ADDENDUM NO. 03

**Westfield Washington School Corporation
Westfield Middle School West (Site Package)
17707 Centennial Road,
Westfield, IN. 46074**

PROJECT: Westfield Middle School – West (Site Package)

DATE: June 24, 2024

DRAWING NUMBER
C250

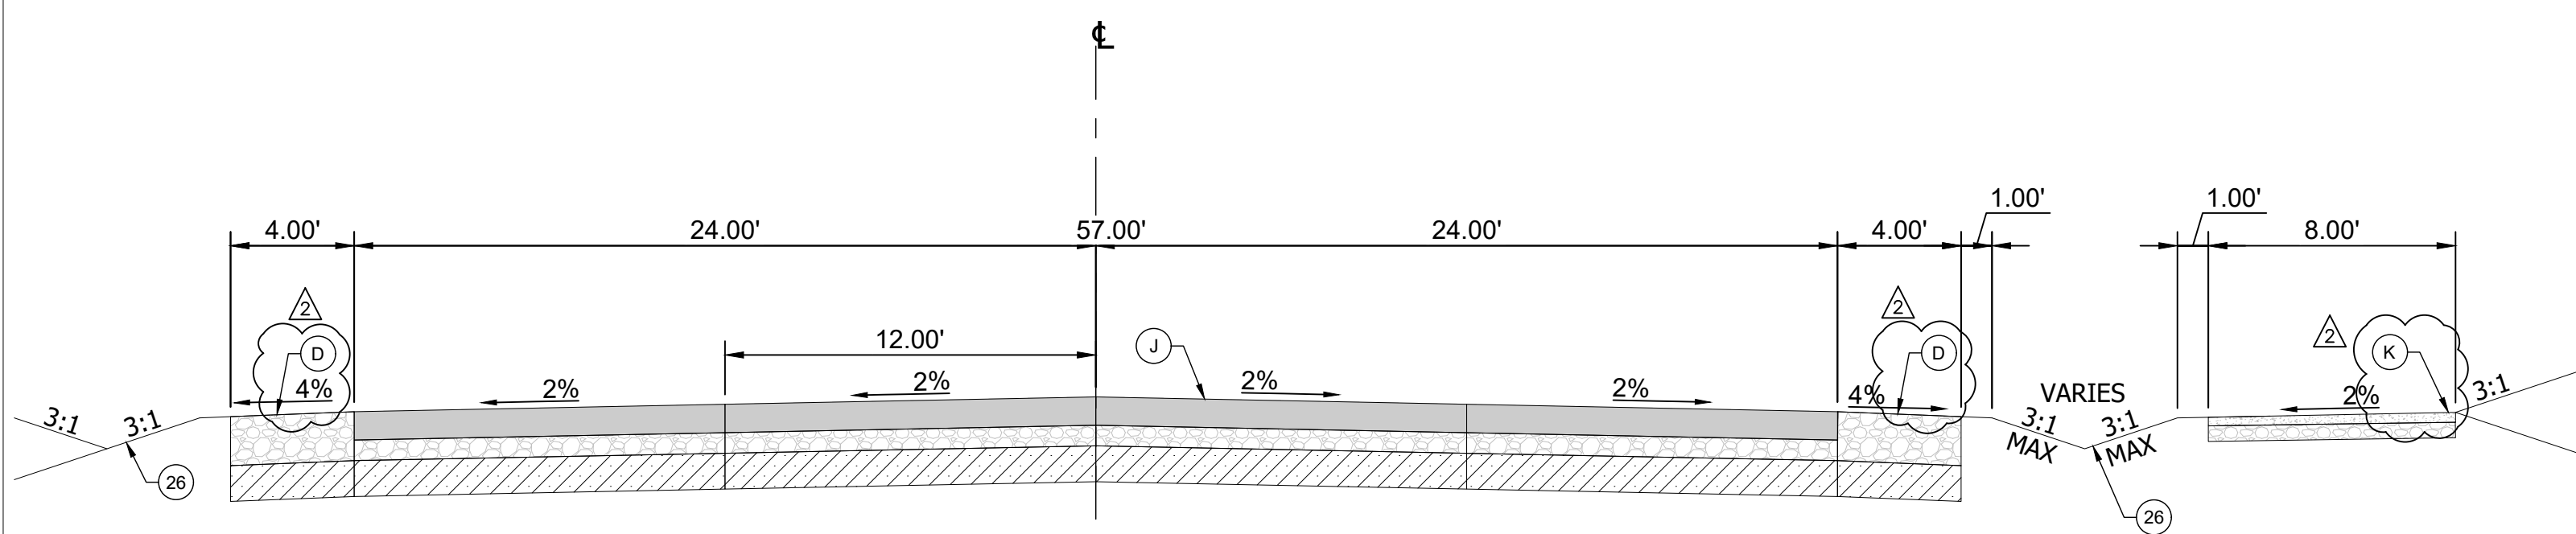
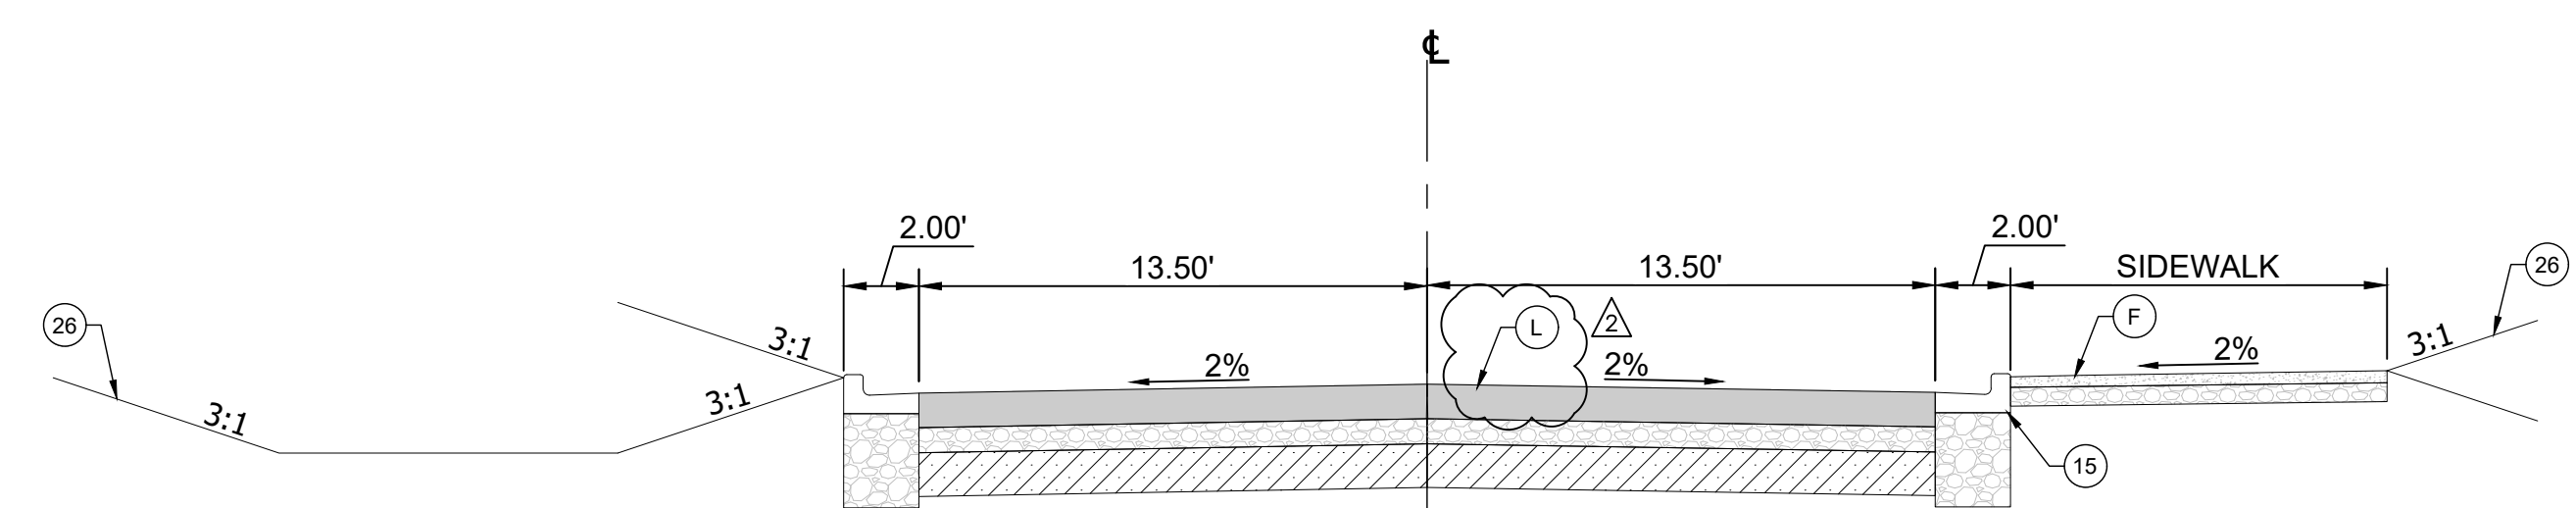
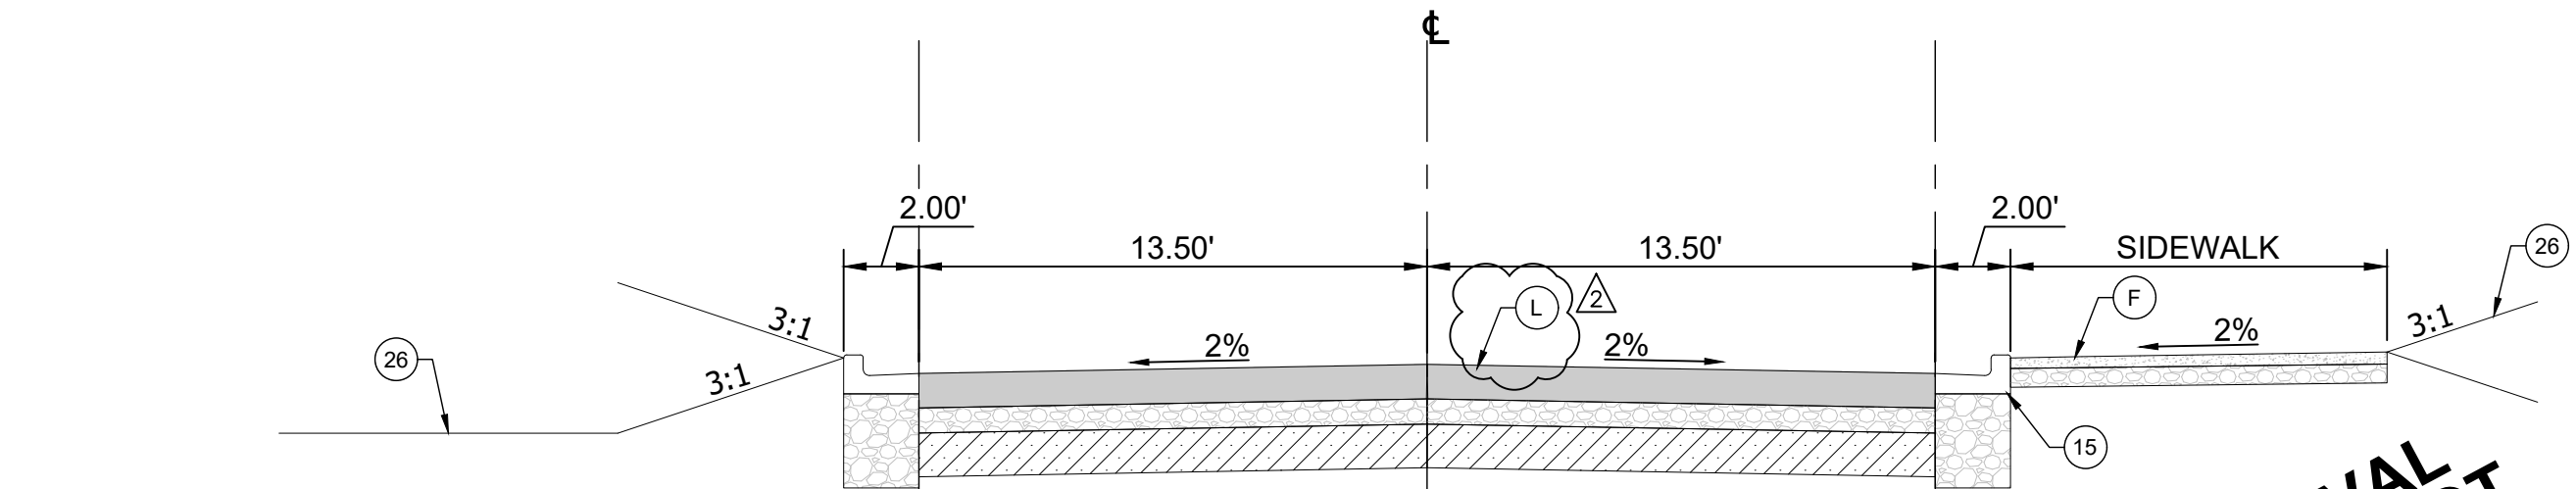
3.2 C250 ROAD PLAN AND PROFILE

- A. Added dimensions to typical section private drives

- B. Switched Call out K to Multi-Use Path call out to match city of Westfield detail
- C. Private Drive call outs to Letter L (see "L-SERIES" plans for material)
- D. Added new call out "D" 4' Wide Stone Shoulder, Compacted INDOT #53 Stone, 8" Deep

DRAWING NUMBER
C251

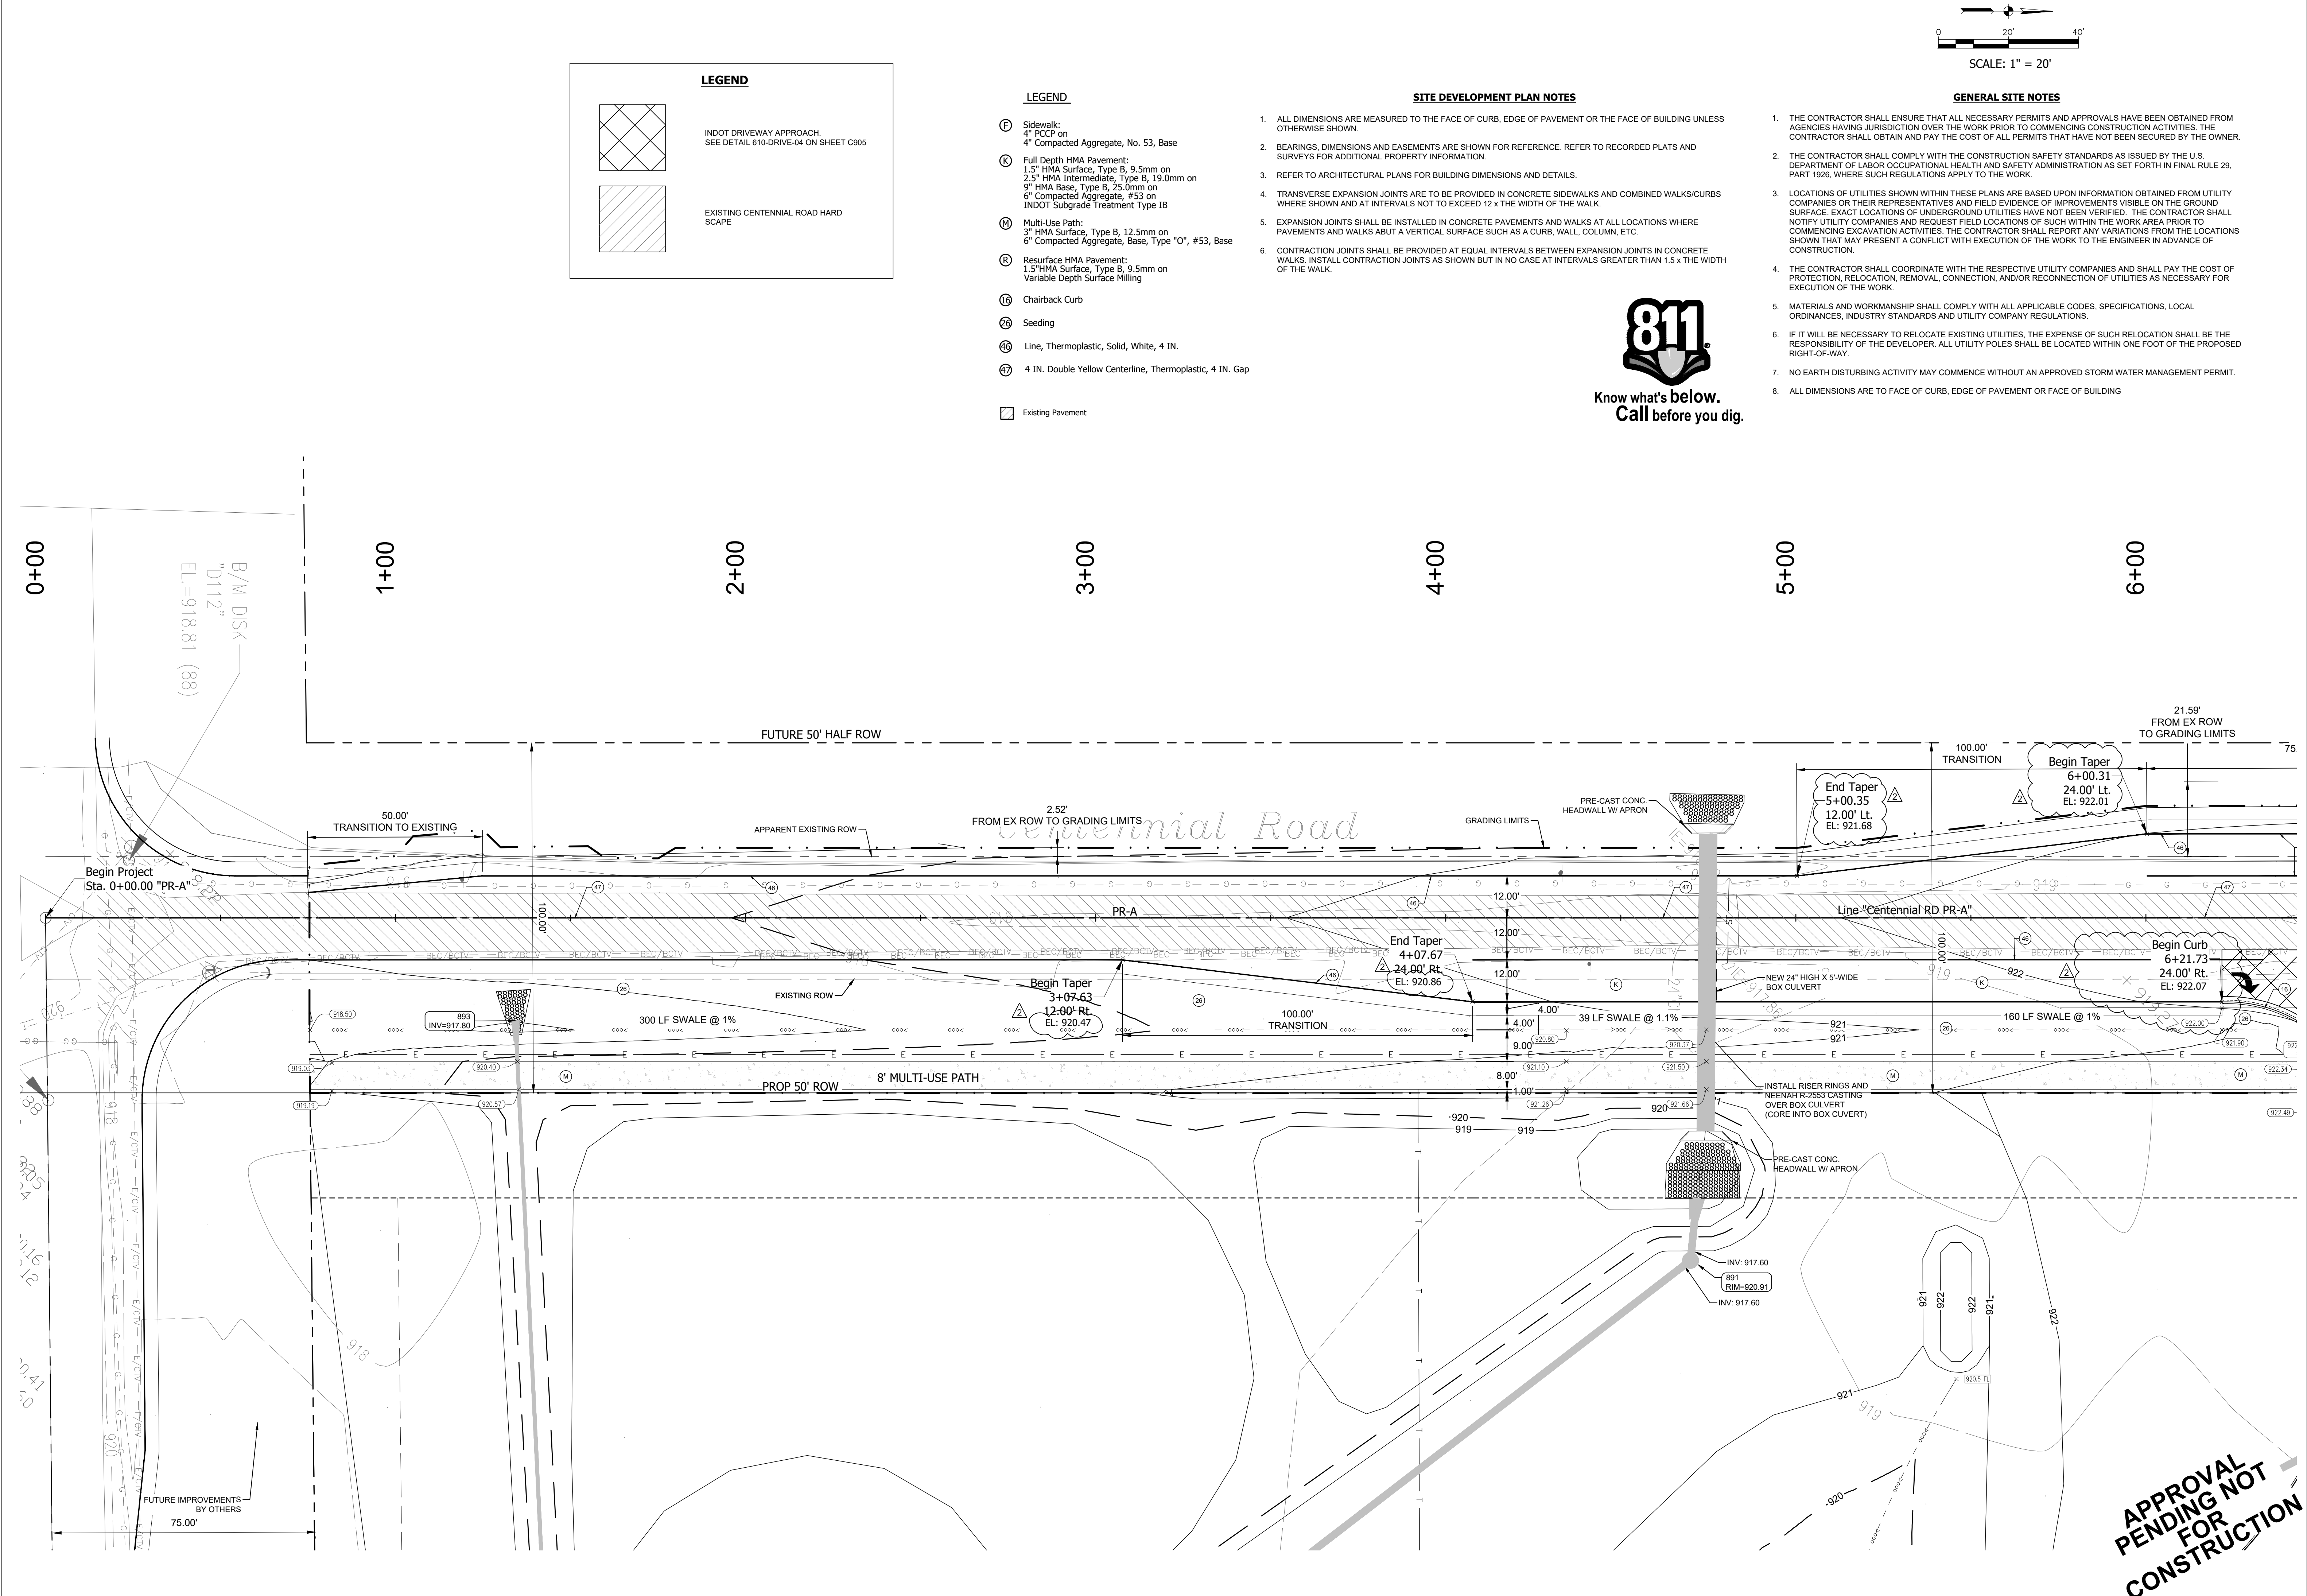
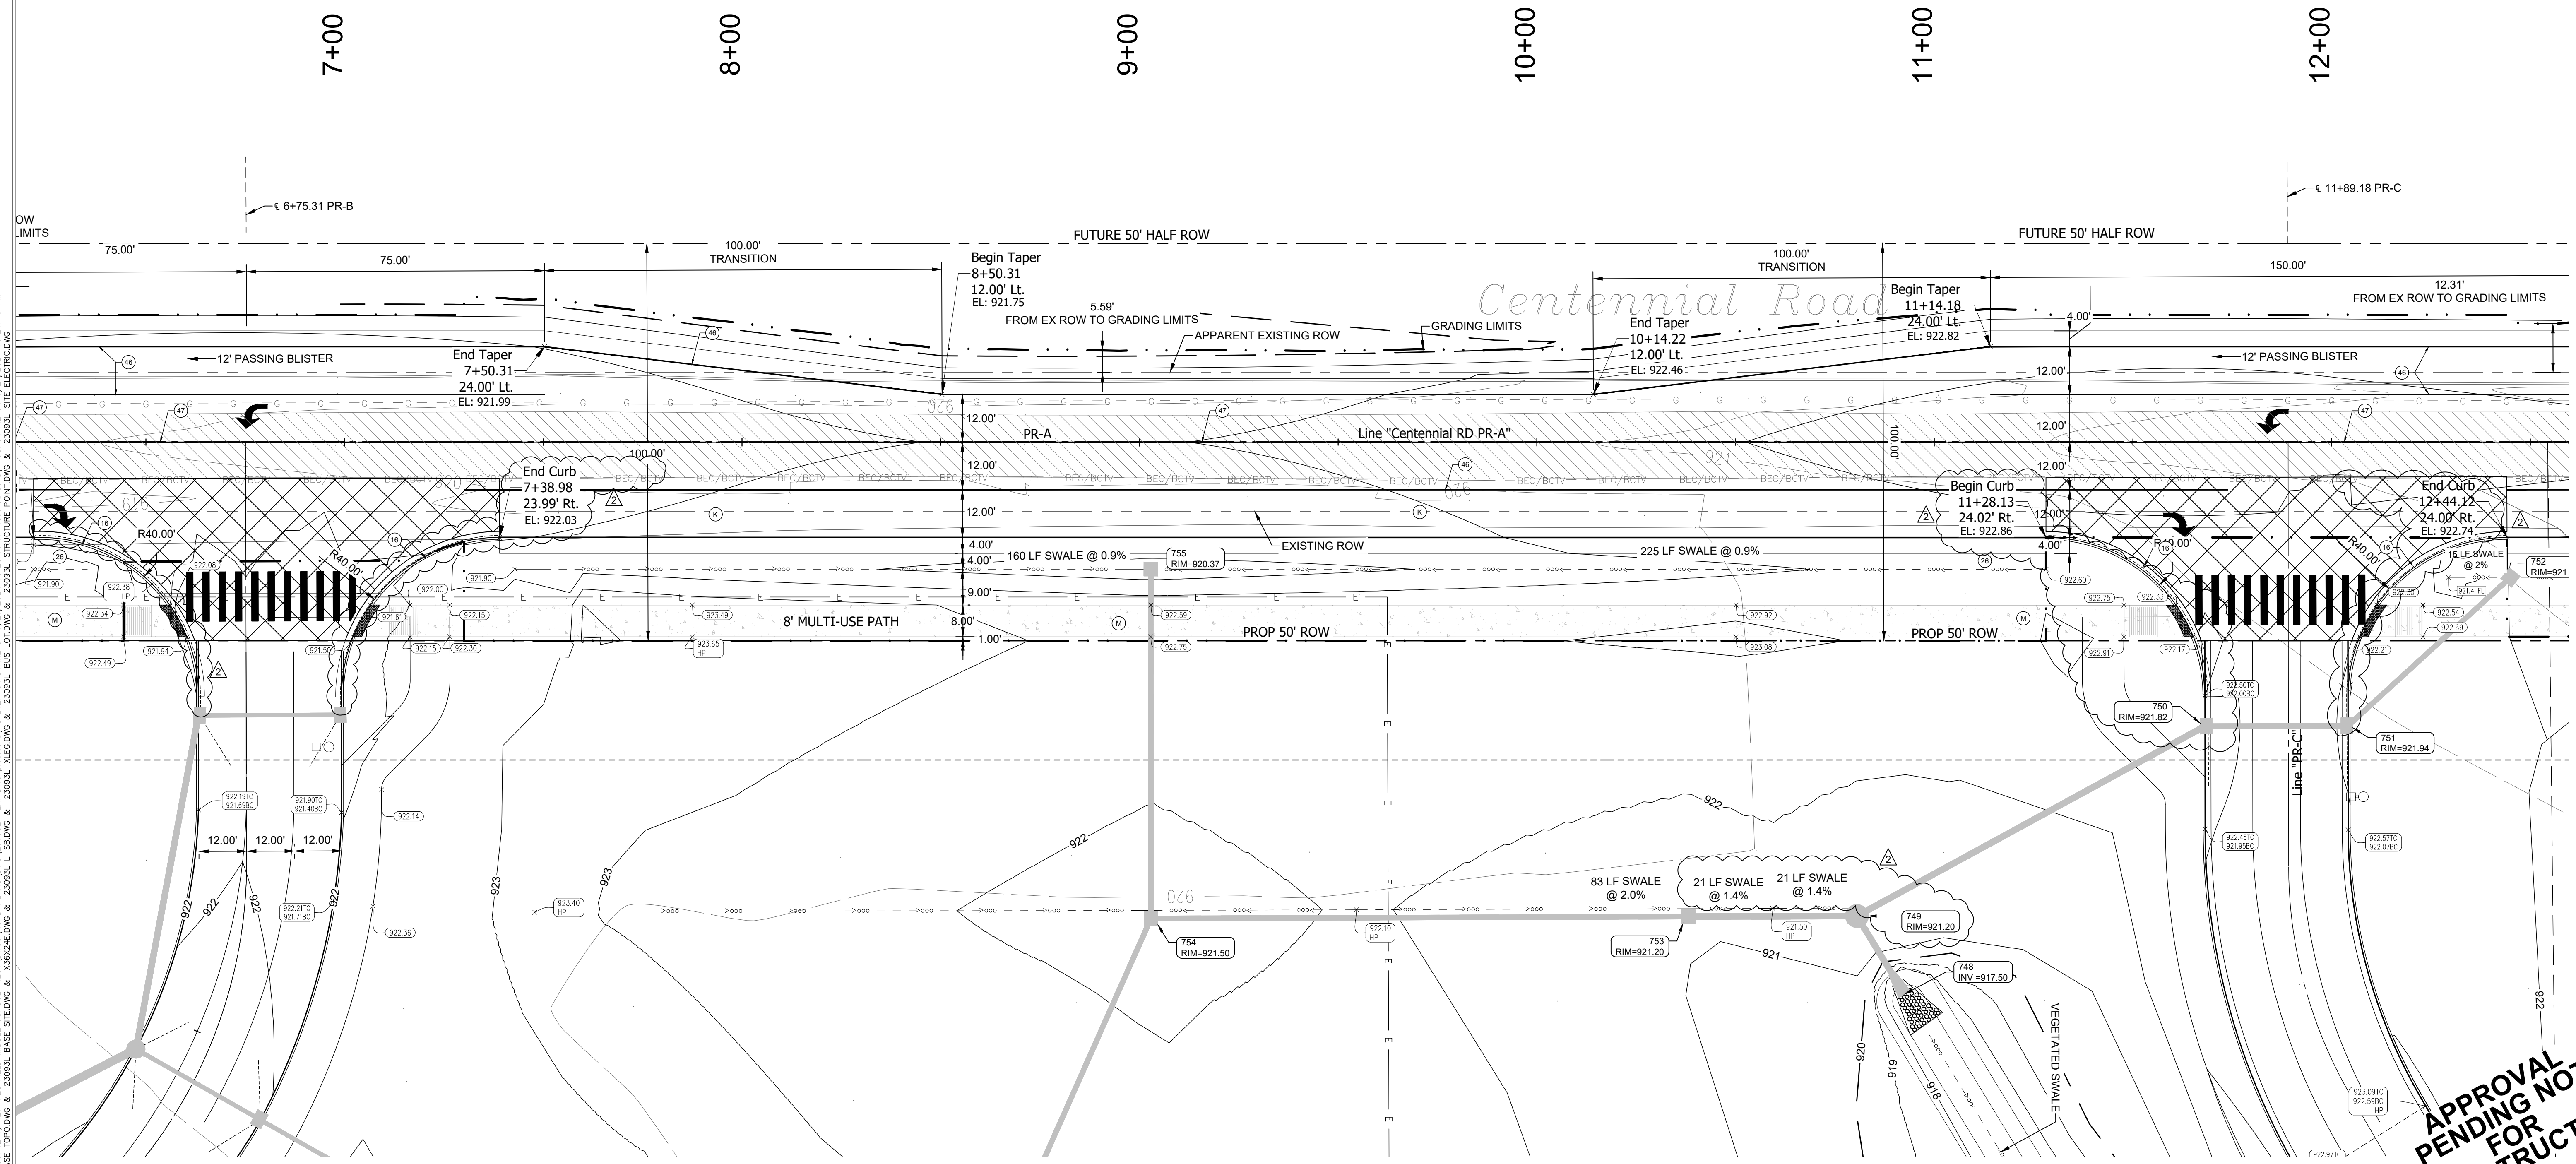
3.3 C251 PLAN PR-A STA.00+00 to STA. 5+80
